# UNITED STATES PATENT AND TRADEMARK OFFICE

APPLICATION NO.	FILING DATE	FIRST NAMED INVENTOR	ATTORNEY DOCKET NO.	CONFIRMATION NO.
10/676,767	10/01/2003	Michael Samuel	522.0001	7915
3404	7590	03/09/2006	EXAMINER	
PURDUE LAW OFFICES 2735 N. HOLLAND-SYLVANIA ROAD SUITE B-2 TOLDEO, OH 43615				CHAN, KO HUNG
ART UNIT		PAPER NUMBER		
		3632

<b>Office Action Summary</b>	<b>Application No.</b>	<b>Applicant(s)</b>	
	10/676,767	SAMUEL, MICHAEL	
	<b>Examiner</b>	<b>Art Unit</b>	
	Korie H. Chan	3632

**DETAILED ACTION**

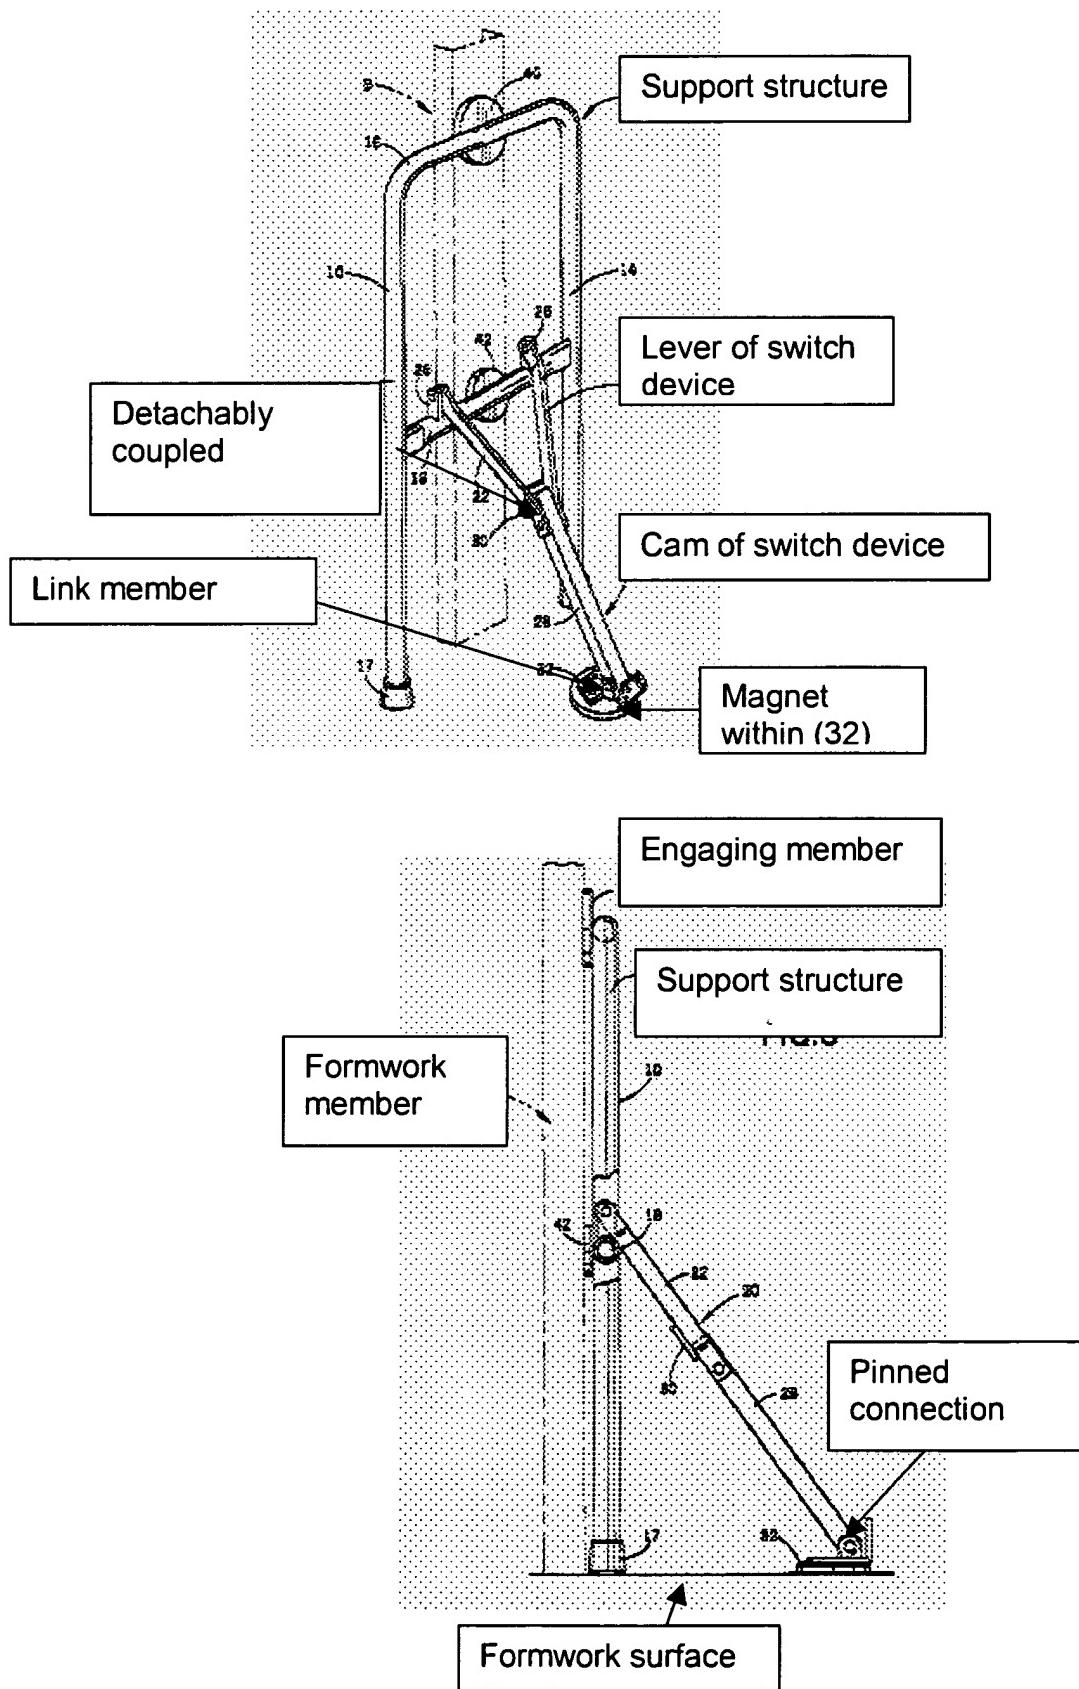
Claims 1-4 and 6-11 are rejected under 35 U.S.C. 102(b) as being anticipated by Schillero, Jr. (US patent no. 6,029,407). Schillero Jr. disclosed all the claimed features of applicant's invention as illustrated below.

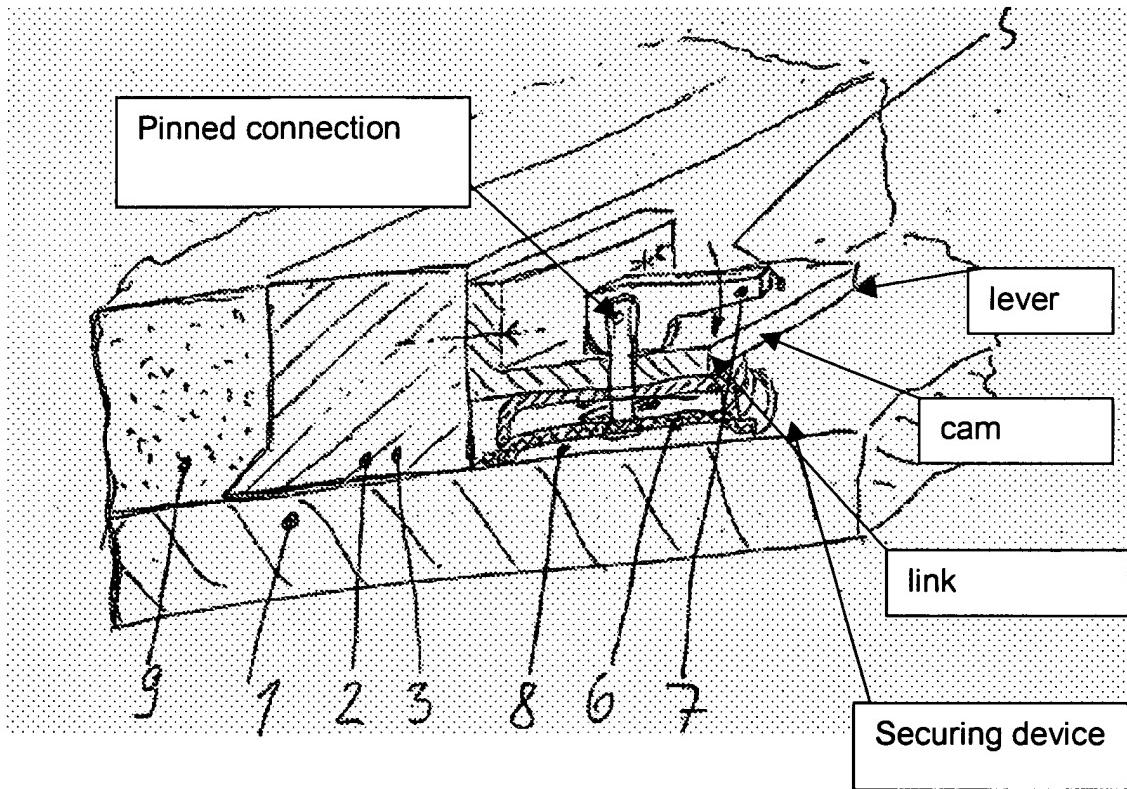
Claims 33 and 34 are rejected under 35 U.S.C. 102(b) as being anticipated by German patent (DE19746452) to Eipel. Eipel disclosed all the claimed features of applicant's invention as illustrated below.

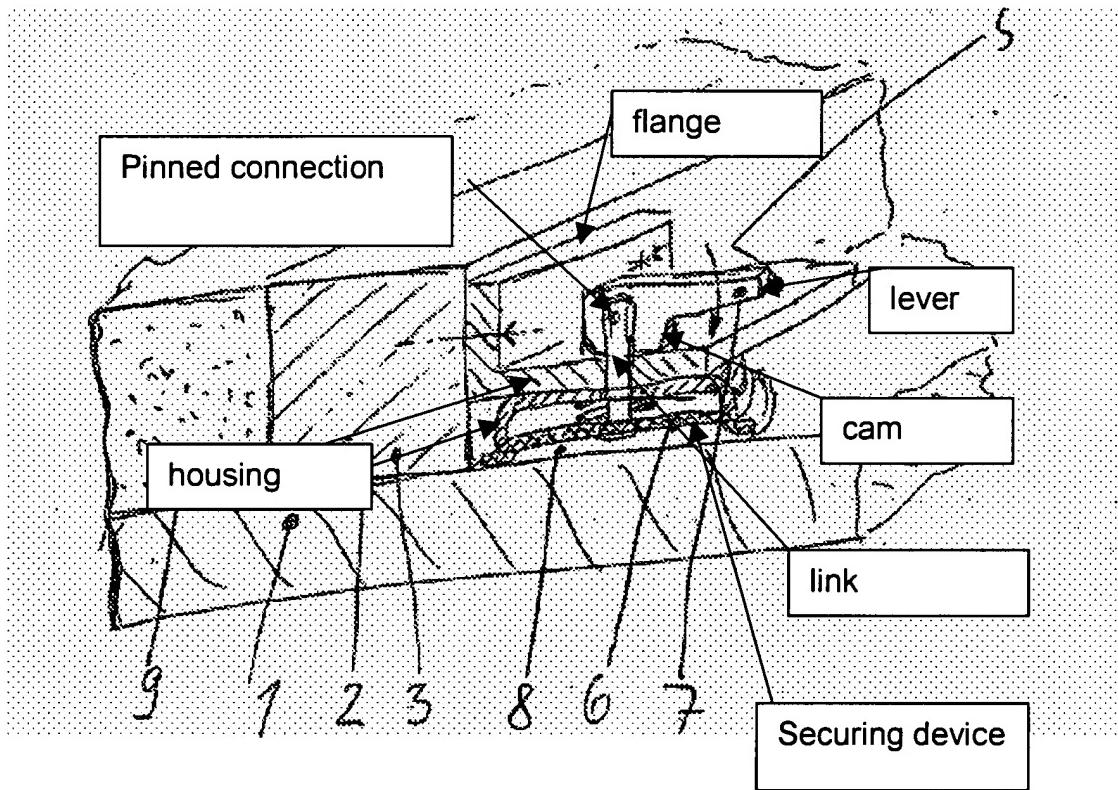
Claims 1-6, 8-12, 15, 16, 22-26, and 28-32 are rejected under 35 U.S.C. 103(a) as being unpatentable over German patent (DE19746452) to Eipel in view of French patent no. (FR2,552,259) to Vavasseur. Eipel disclosed all the claimed features of applicant's invention as illustrated below.

However, Eipel does not disclose the securing element is a magnetic element but rather a suction cup element and flange with aperture for fastener. Vavasseur teaches in a supporting apparatus for supporting formwork member comprising a magnetic supporting element (9) within the housing and a flange (4) with apertures for fastener. It

would have been obvious to one of ordinary skill in the art to have modified the suction cup of Eipel such that it is of the magnetic type since they are well-known mechanical equivalents and to provide apertures to the flange for fastening to the formwork as taught by Vavasseur.
